Subject: Virgil C. Summer Nuclear Station
Docket No. 50/395
SQRT-Additional Questions

RESPONSE TO SORT CONCERNS EXPRESSED BY BNL

ATTACHMENT II

EXHAUST SILENCER AXIAL DIRECTION

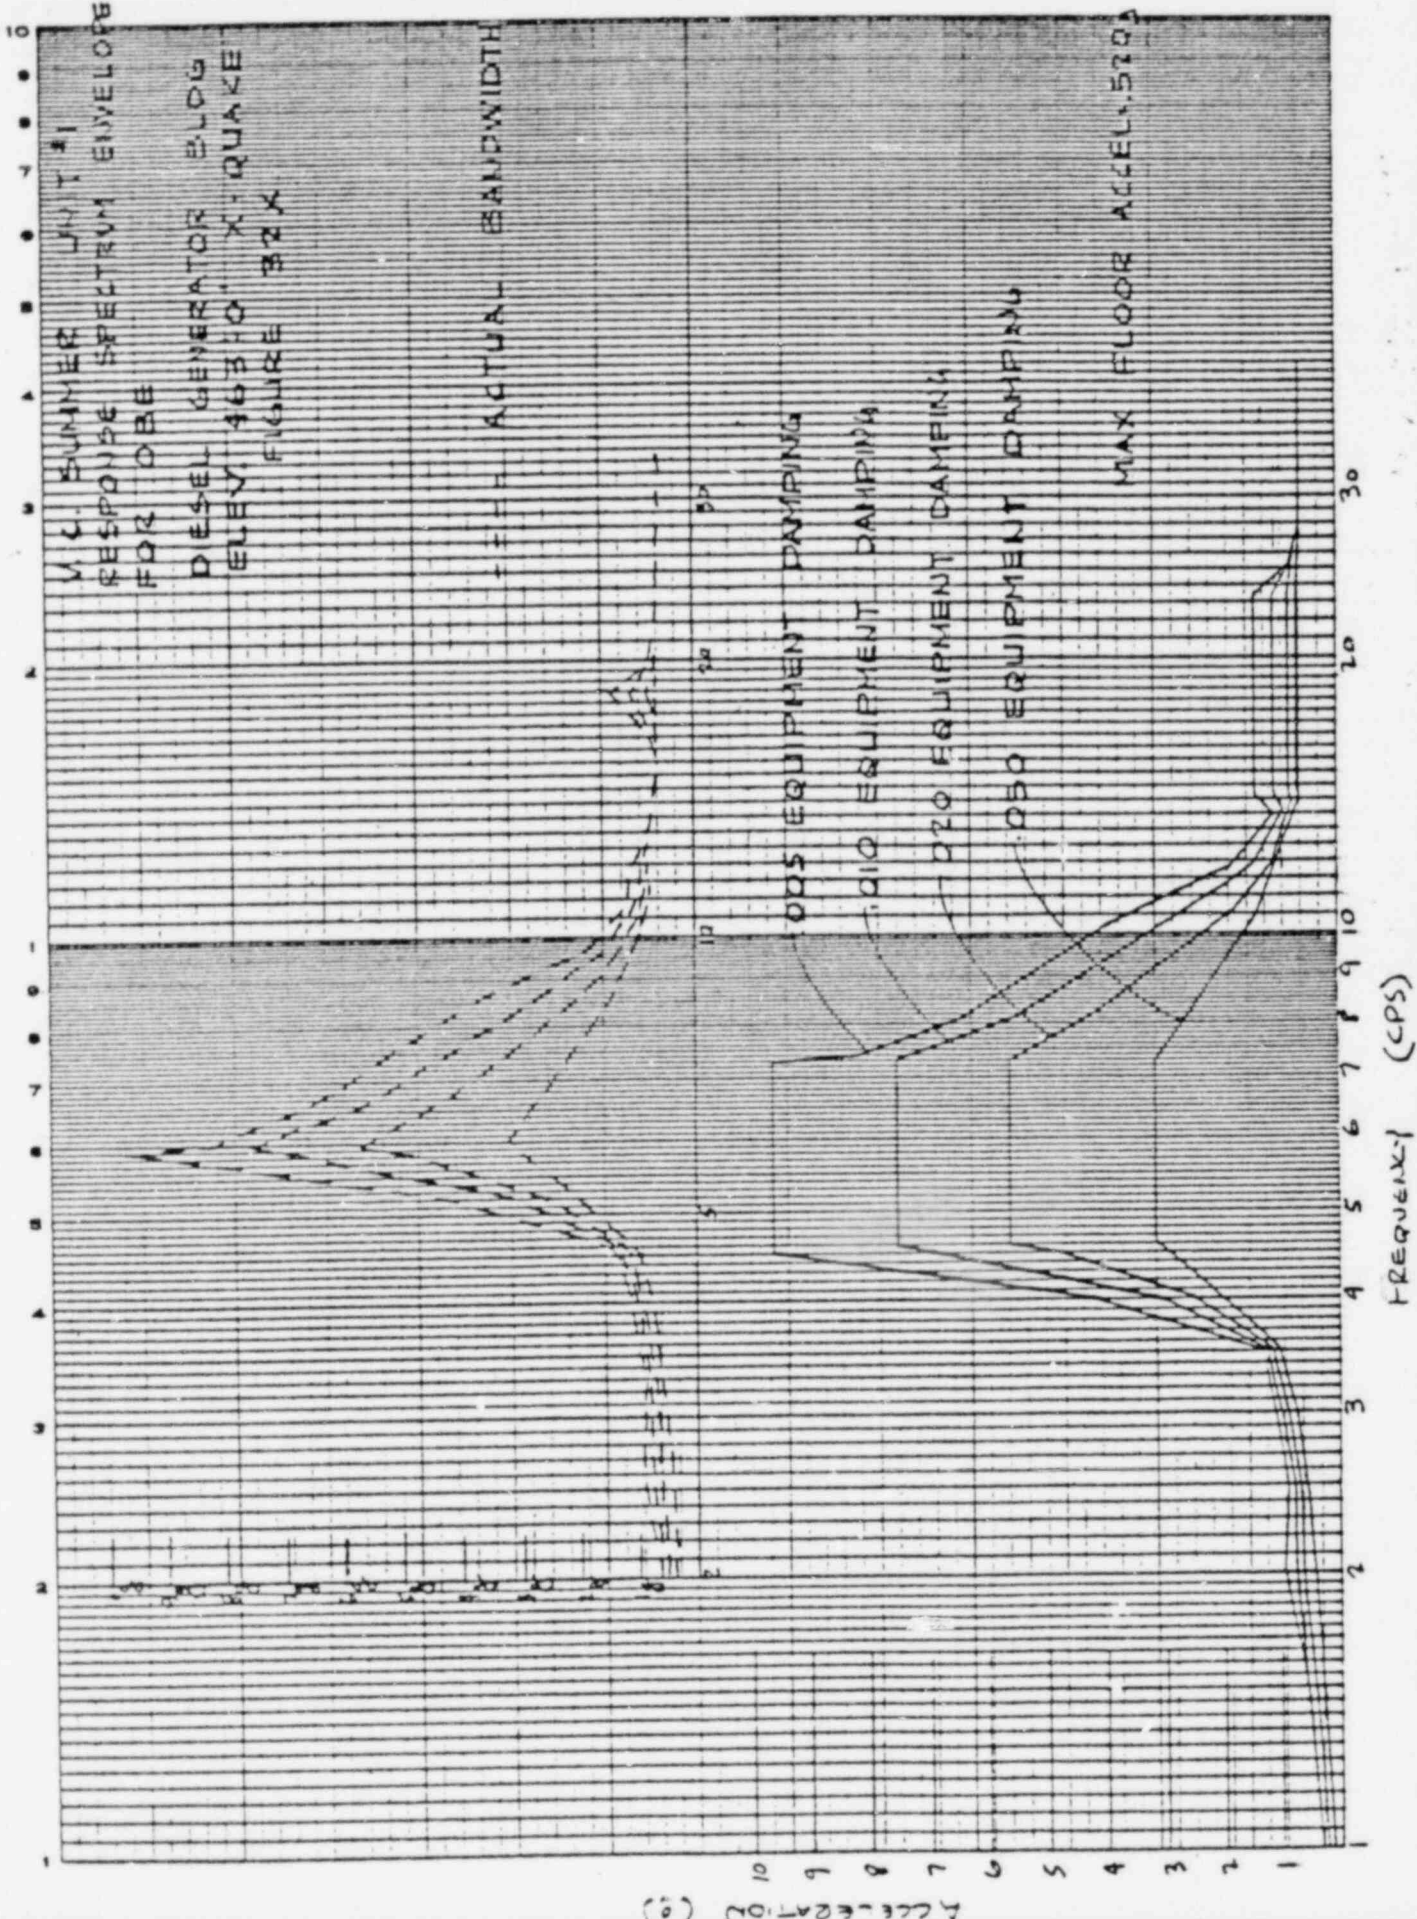
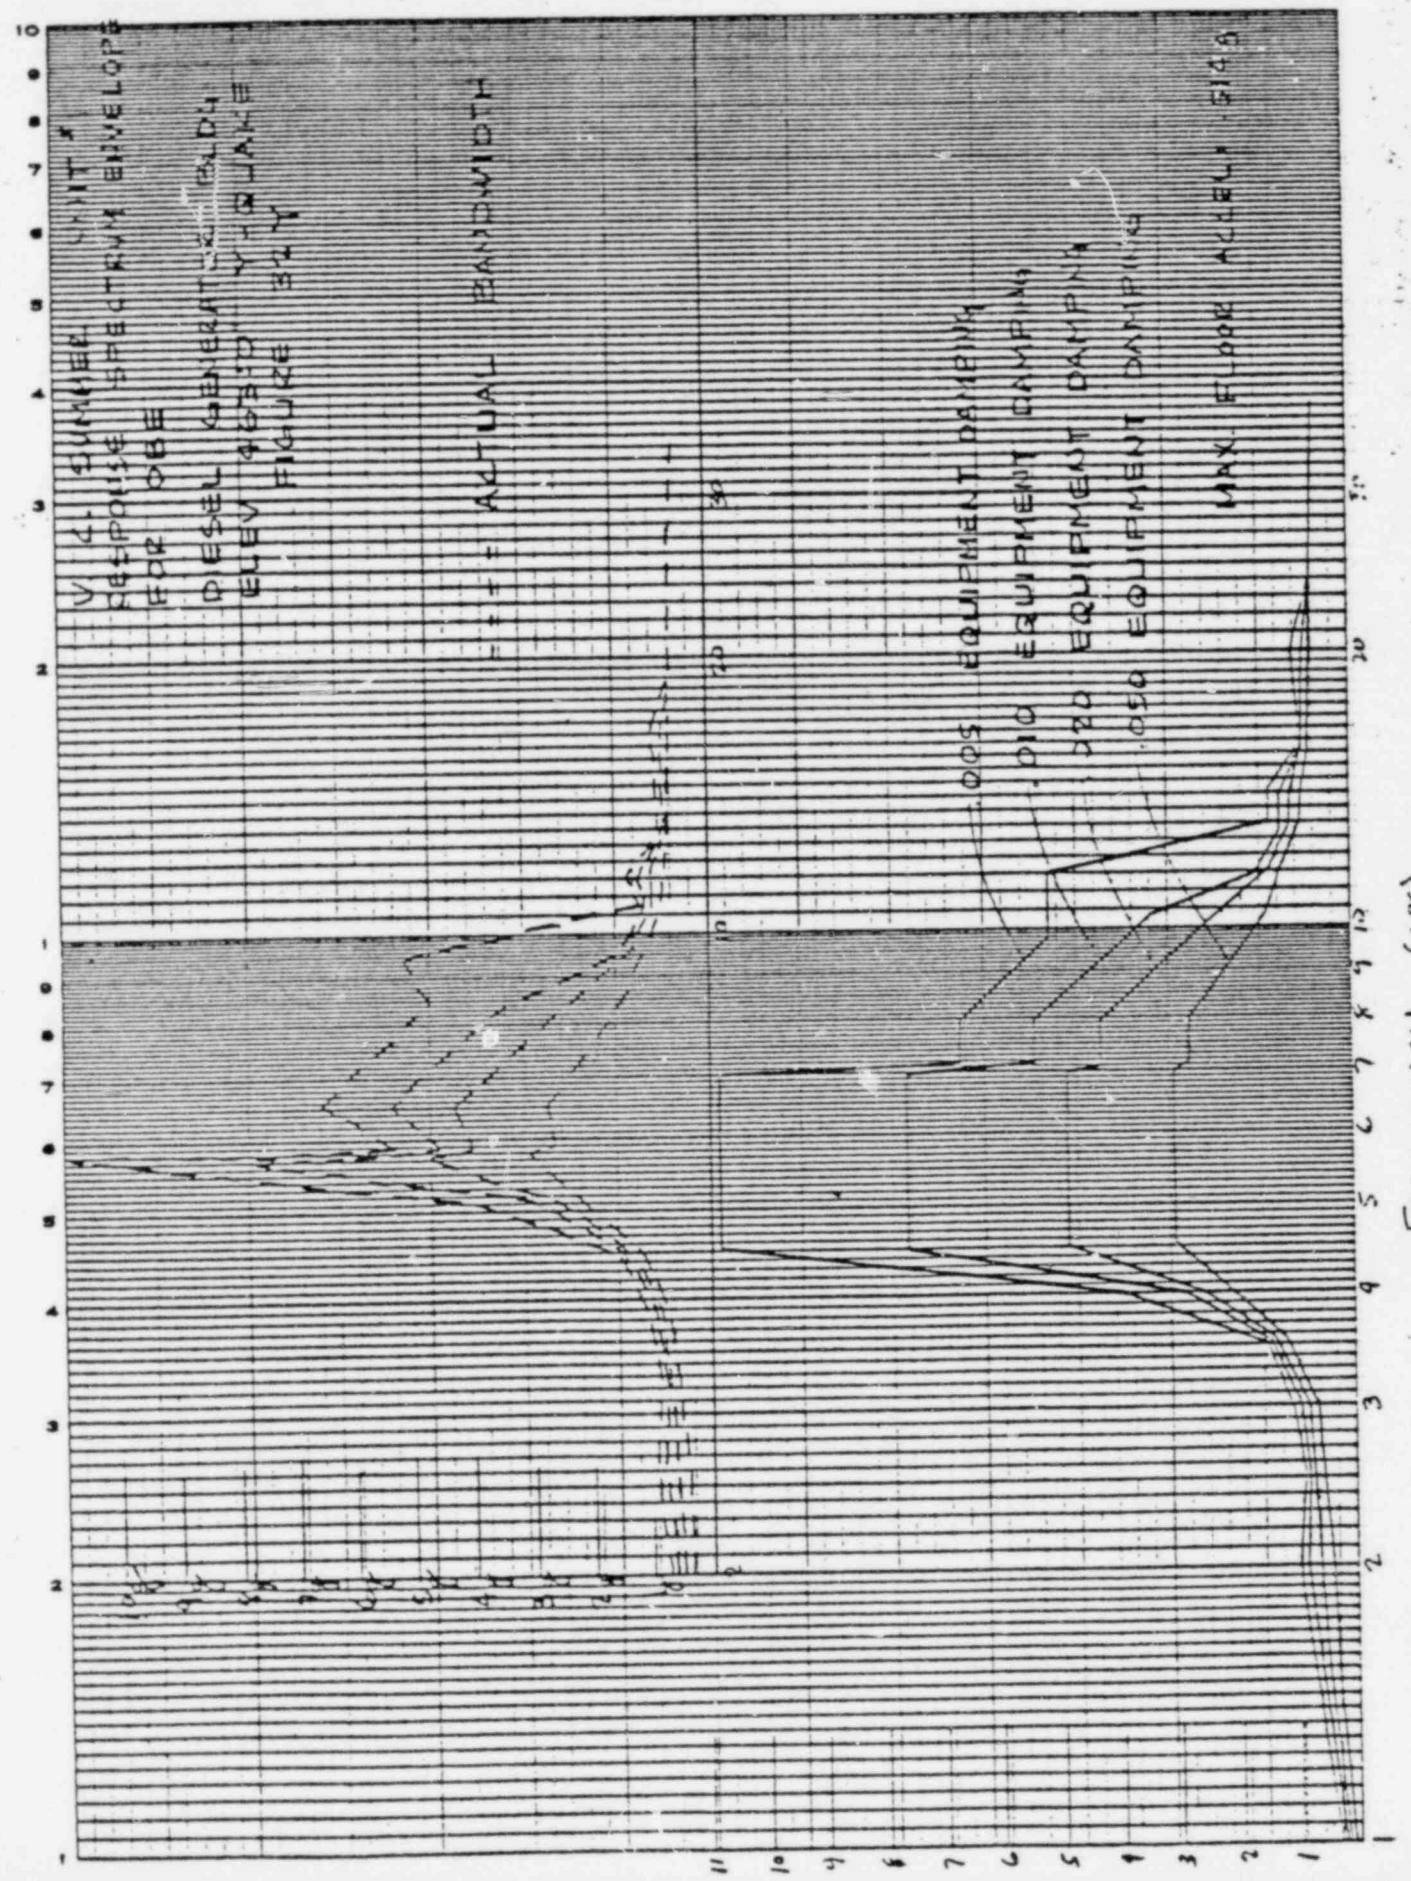
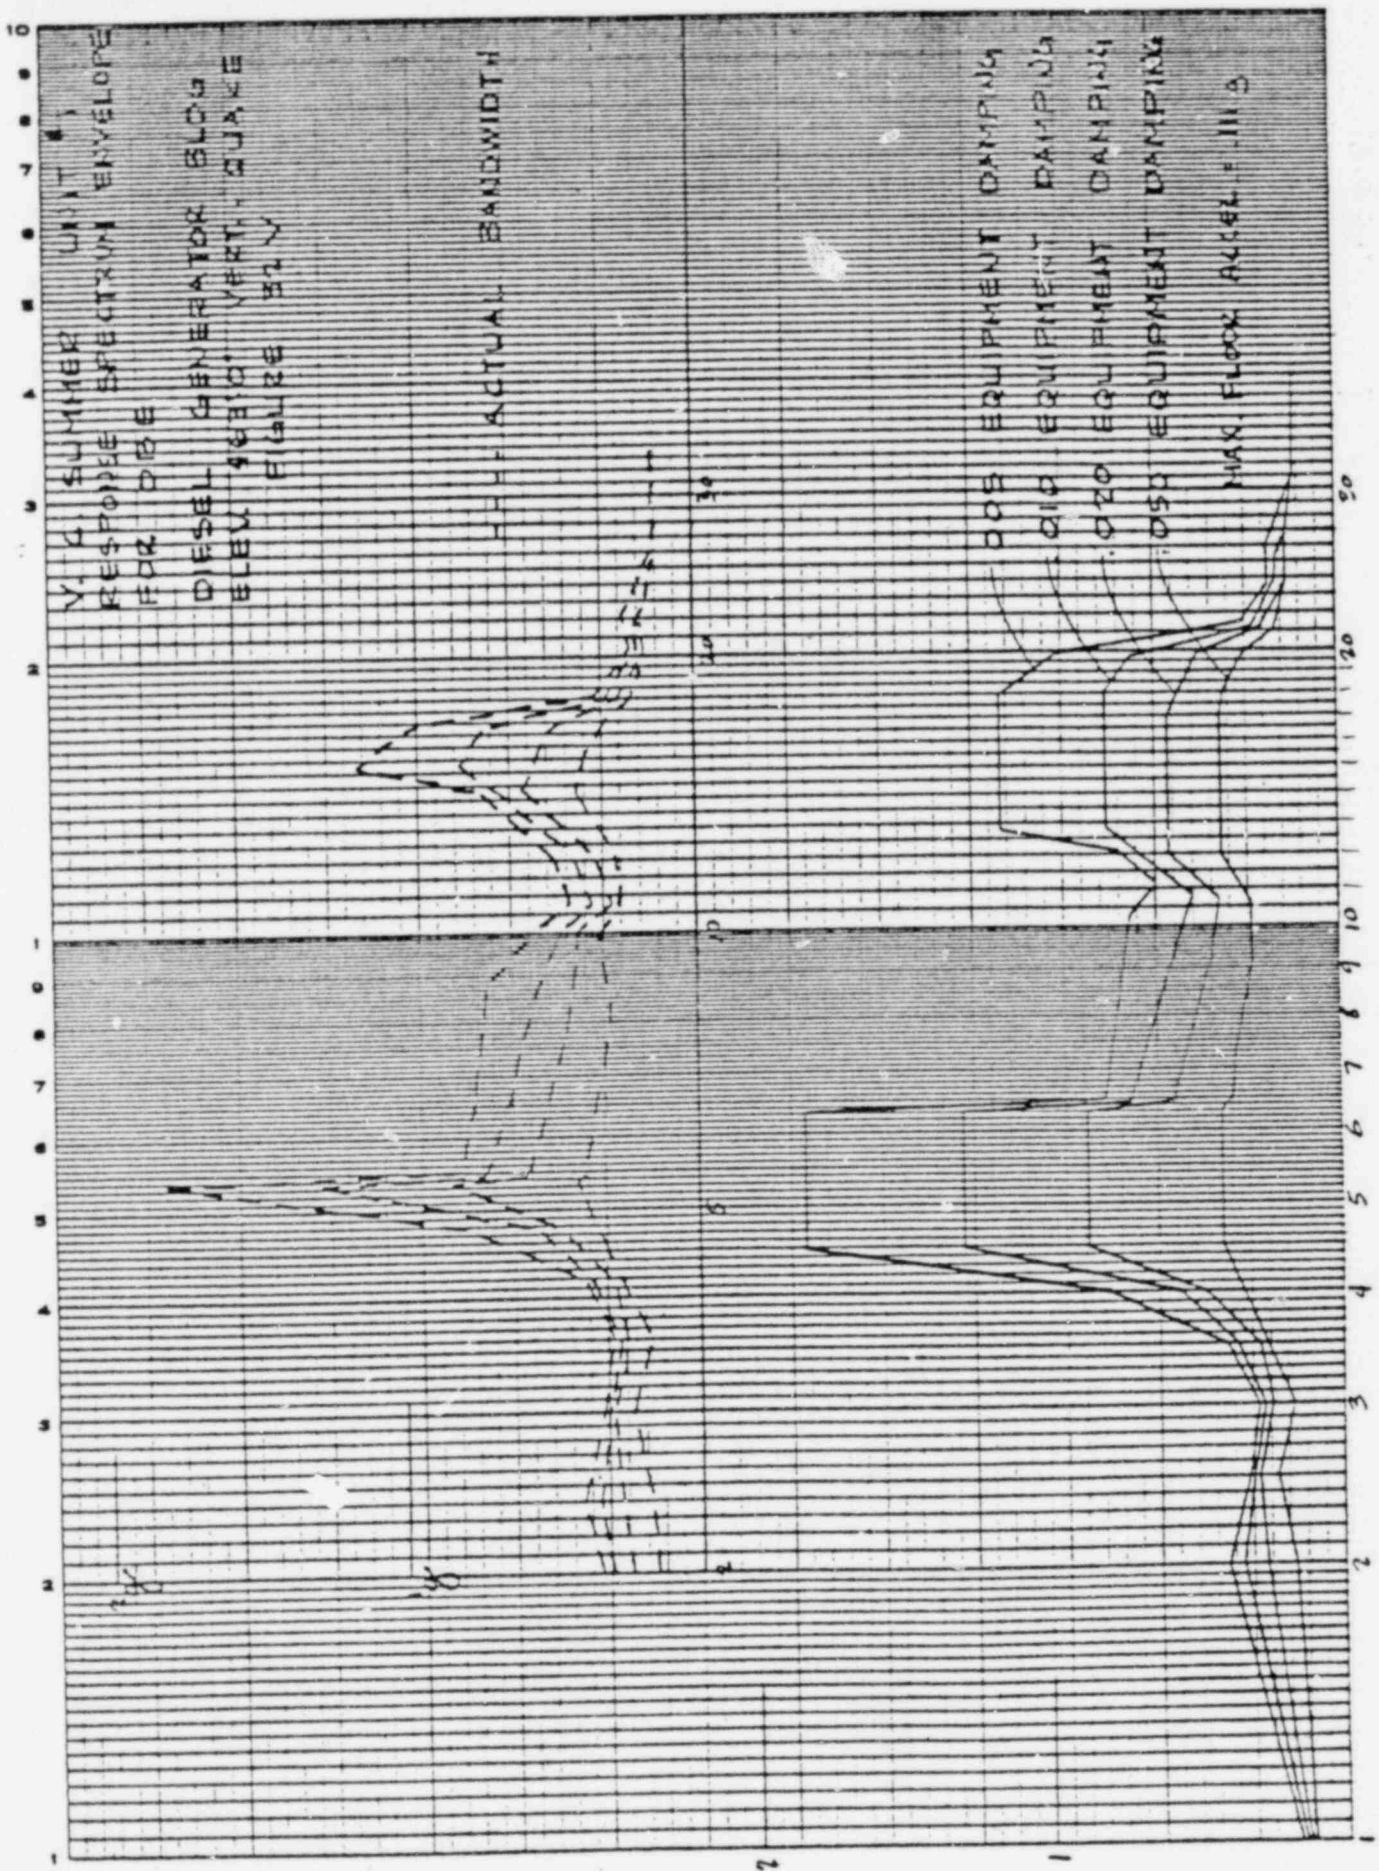
1. To clarify whether the direction of loading considered in frequency calculation by Raleigh method coincides that of the first-mode shape of the equipment response.

2. Assess the discrepancy in frequency calculation using a one-degree-of-freedom system as reported against a combined three-degree system.
3. Provide justification that the equipment is still qualified, with due consideration of items 1 and 2, if the equipment natural frequency is proved to have been overestimated.

Colt Industries analyzed the silencer for a frequency of 24 Hz, which corresponds to an acceleration of 1.26 g. This frequency lies at the right edge of the second peak on the response spectrum. A frequency down to 14 Hz would still correspond to an acceleration of 1.26 g and a higher frequency would result in a lower acceleration. (Response spectrum for 2% equipment damping.) See Attachment #2.

Therefore Glt Industries' calculations for the exhaust silencer are found to be adequate and the equipment is still qualified.
